APPLICABILITY: 2018-21 Crosstrek
SUBJECT: Cowl Panel – Design Change

NUMBER: 12-321-21
DATE: 07/19/21

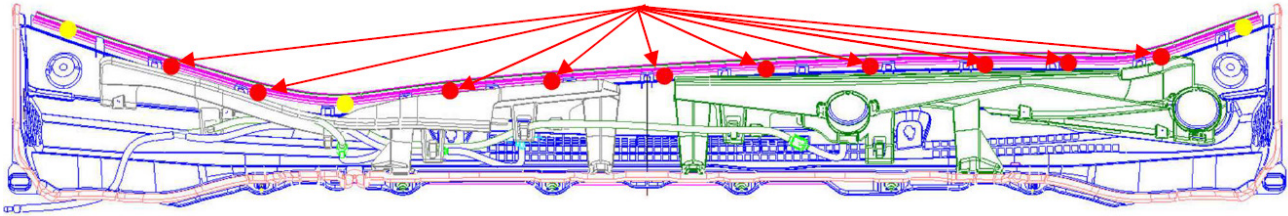
This bulletin announces a design change made to the cowl panel. These new parts utilize ten additional fixing points between the cowl panel and its rubber protector. This change was made to address a small number of cases where the rubber sealing portion had become separated as shown below. If this issue is confirmed, the cowl panel must be replaced.
